Notice of Allowability

10/550,654

TSURUYA, MAMORU

EXAMINER'S AMENDMENT

Prior Art
FIG. 1

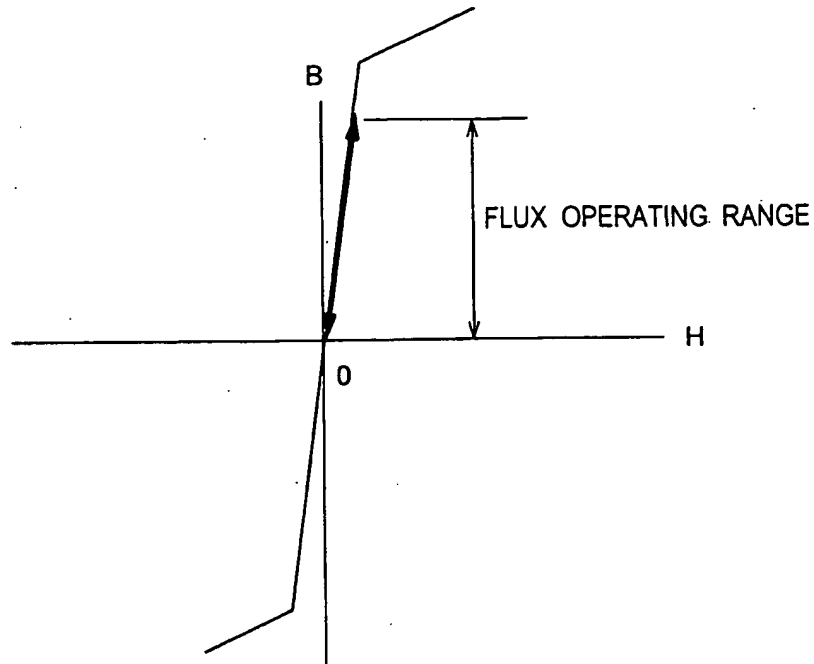
1. The following changes to the drawings have been approved by the examiner: figures 1-4 have been labeled --Prior Art-- because only that which is old is illustrated. See MPEP § 608.02(g).
